METROPOLITAN GOVERNMENT OF NASHVILLE AND DAVIDSON COUNTY

STAFF RECOMMENDATION
4119 Aberdeen Road
December 21, 2016

Application: New construction-addition
District: Cherokee Park Neighborhood Conservation Zoning Overlay
Council District: 24
Map and Parcel Number: 10308021300
Applicant: Preston Quirk
Project Lead: Robin Zeigler, robin.zeigler@nashville.gov

1 **SITE PLAN**
SCALE: 1" = 20'

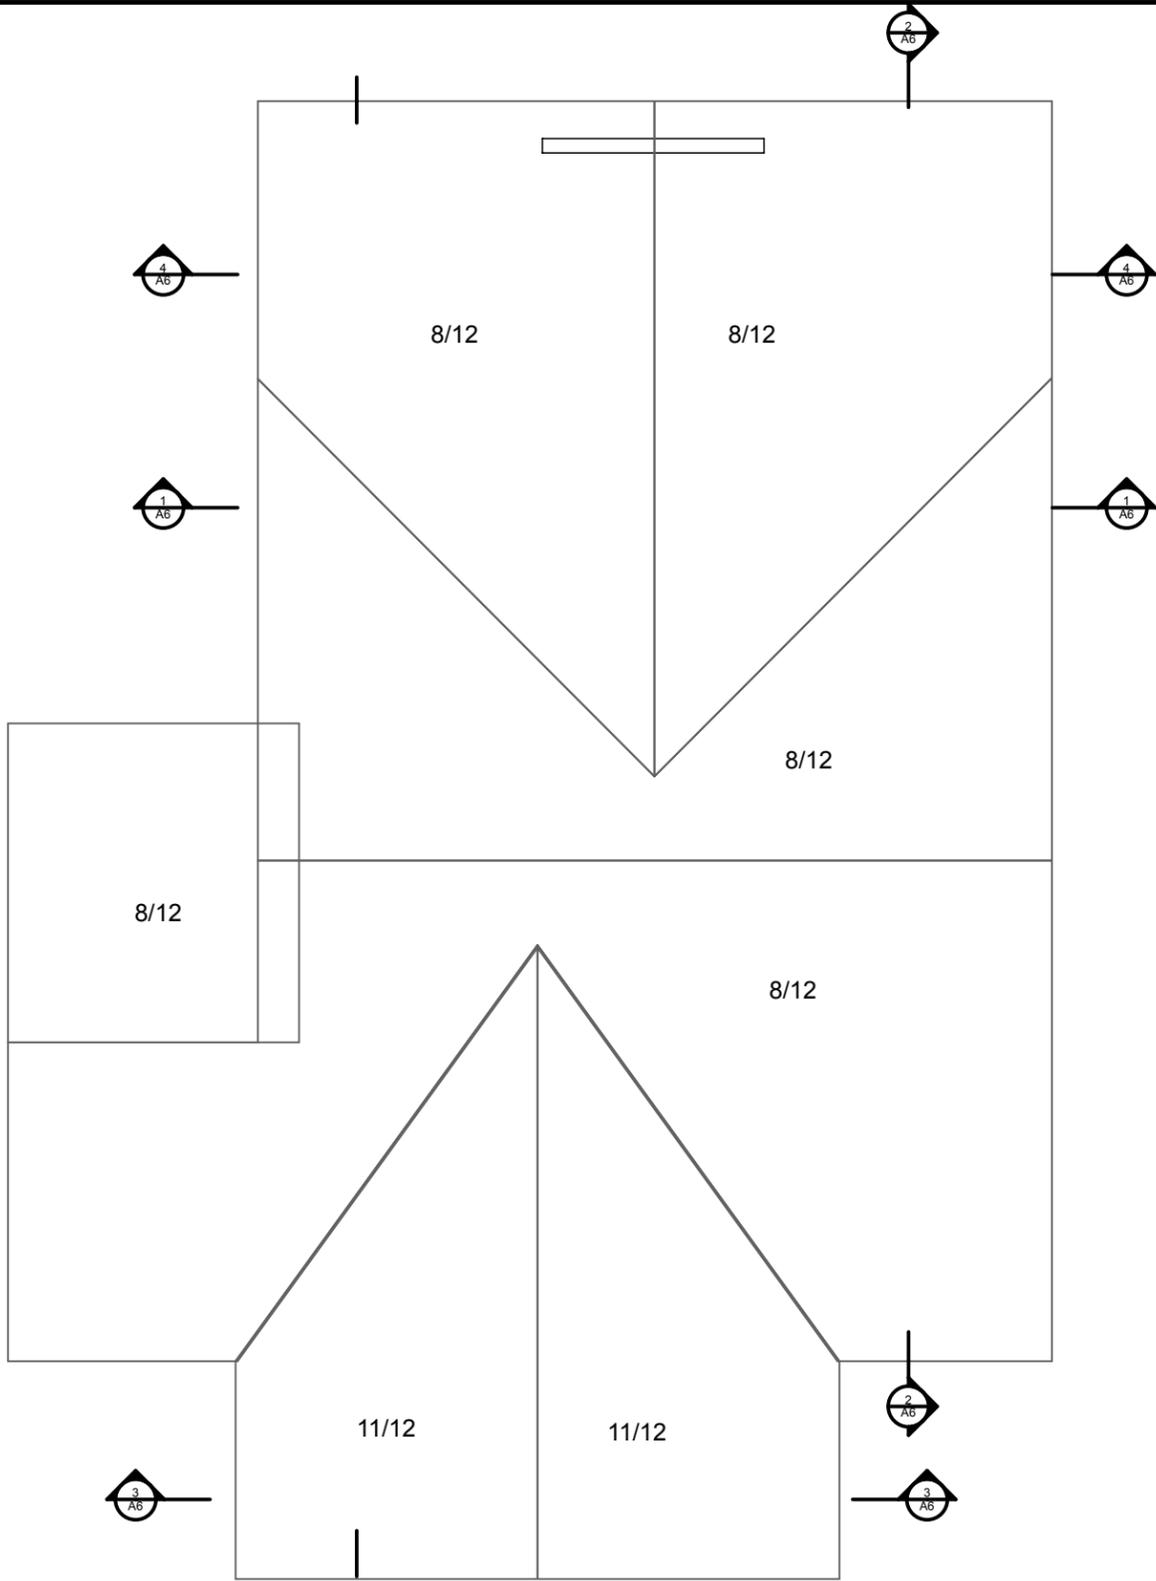
Setback & Rhythm of Spacing: The rhythm of spacing will not change from existing conditions. In addition, existing conditions, in regards to spacing, are compatible with the historic character of the neighborhood and meets bulk standards. The setback will decrease by approximately ten feet (10’) due to the addition of a front screened porch. Staff finds this to be appropriate as the new setback will be similar to the existing house on the left and the front addition is minimal in massing, being a one-story, open porch. The project meets section II.B.1.c.

Appurtenances & Utilities: No changes to the site's appurtenances were indicated on the drawings. The location of the HVAC and other utilities was also not noted. Staff asks that the HVAC be located on the rear façade, or on a side façade beyond the midpoint of the house. The project meets section II.B.1. i.

1 FRONT ELEVATION
SCALE: 1/8" = 1'-0"

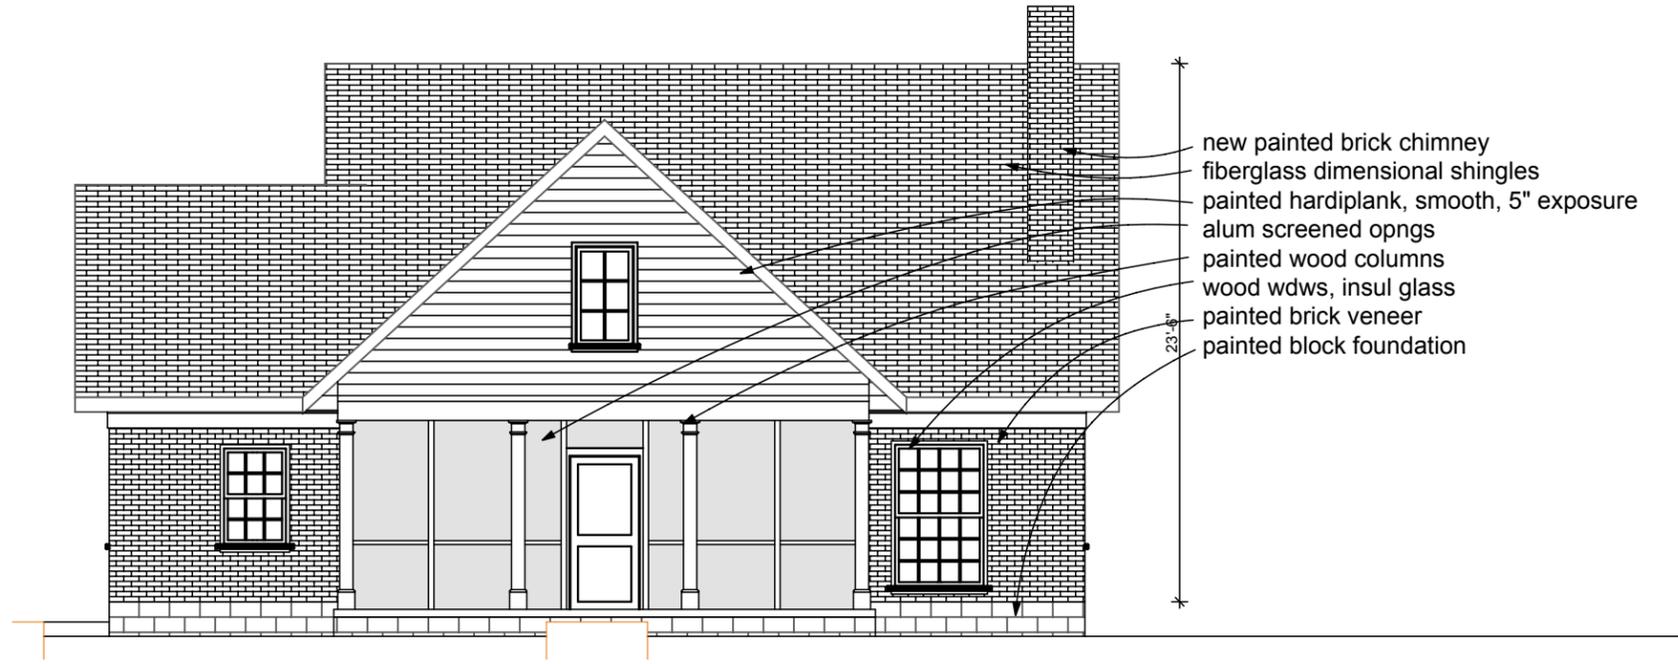
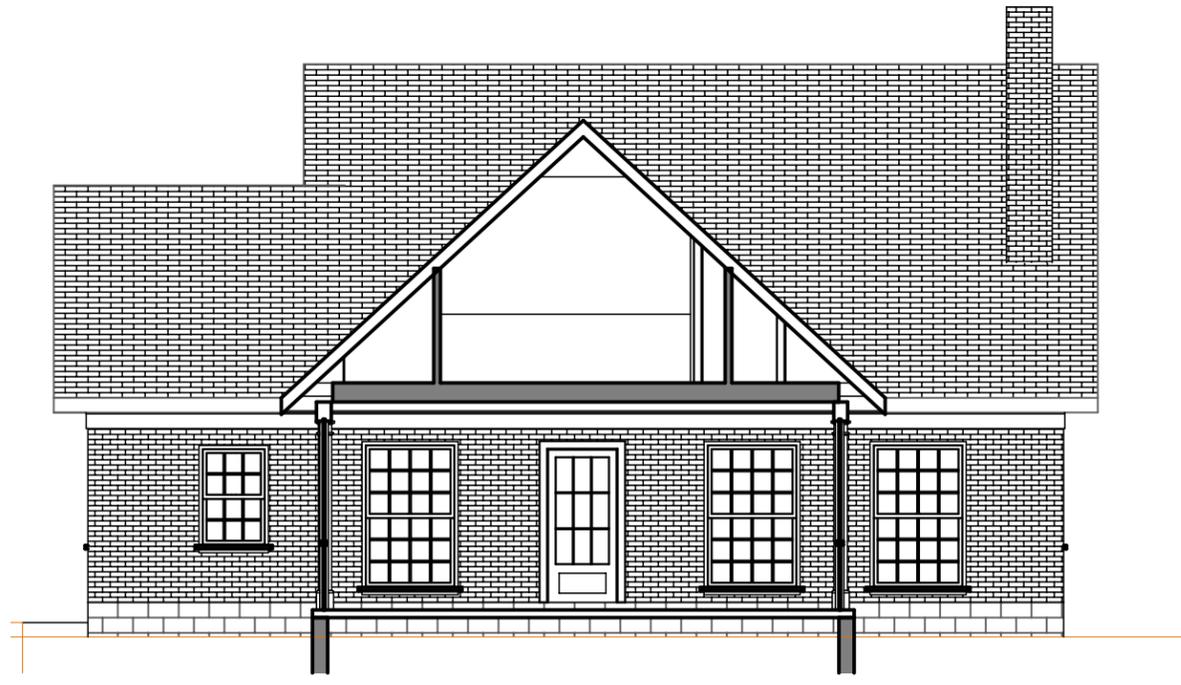
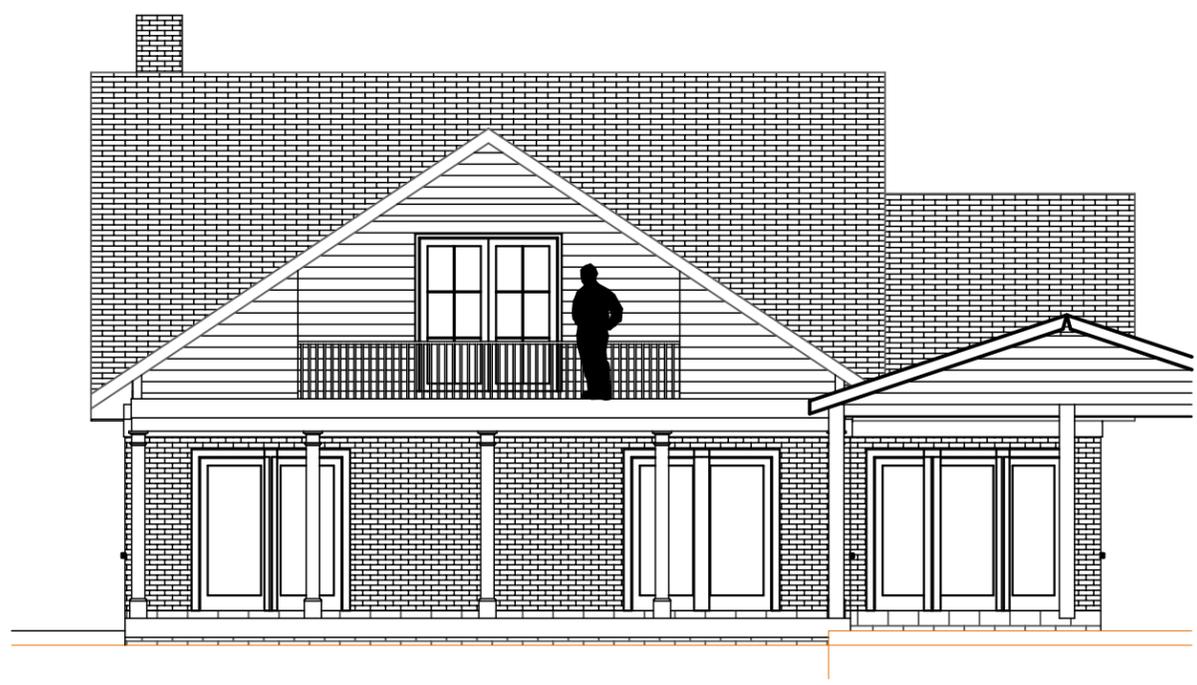
Height & Scale: The home incorporates an existing non-contributing home so the foundation height will not change. The eave heights also are not proposed to change; however, the overall height will increase to approximately twenty-four feet (24’) from finished grade. Staff finds this to be appropriate as the homes to either side, which are typical of the neighborhood, are approximately 23’ and 28’tall from grade. The width of the home will not change. The project meets section II.B.1.a.and b.

Roof form: The new roof form will be a side gable with an 8/12 pitch. The front porch is gabled with an 11/12 pitch. Both the pitches and forms are typical of the neighborhood. An interior-side brick chimney will be added. The project meets section II.B.1.e.

Proportion and Rhythm of Openings: The windows are all generally twice as tall as they are wide, thereby meeting the historic proportions of opening, with one exception that is an existing window. There are no large expanses of wall space without a window or door opening. Staff finds the project's proportion and rhythm of openings to meet Section II.B.1.g.
